Re: #09ITB66497K-JD – 10th Floor Terraces Waterproofing

**#09ITB66497K-JD – 10th Floor Terraces Waterproofing
Addendum No. 2
Page Two**

This Addendum forms a part of the contract documents and **modifies** the original ITB documents as noted below:

15 PARAPET WALL SILL (REVISED)
 A104 1-1/2"=1'-0"

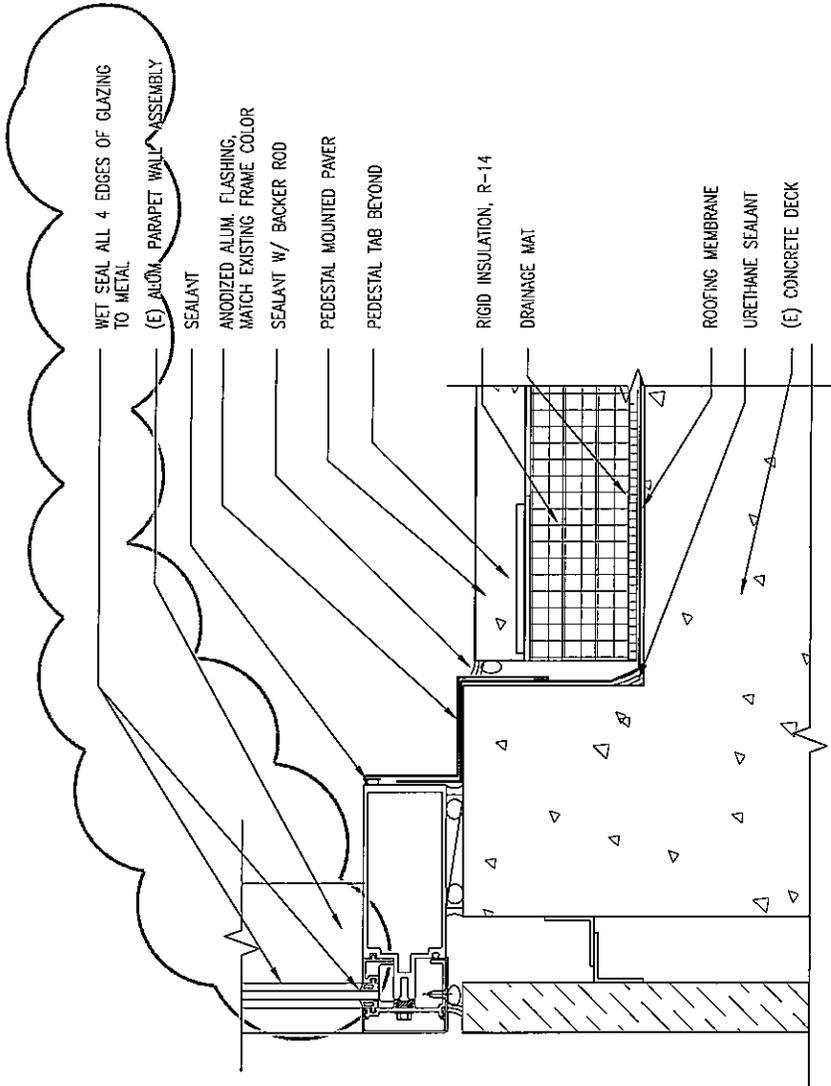
8. Question: Provide details of existing construction of building granite panels and low parfalt panels at terraces.

Answer: Details of the existing construction in that area is the same as detail 10/A104. See attached Exhibit 2, Revised Drawing, Parapet Wall Sill (Revised).
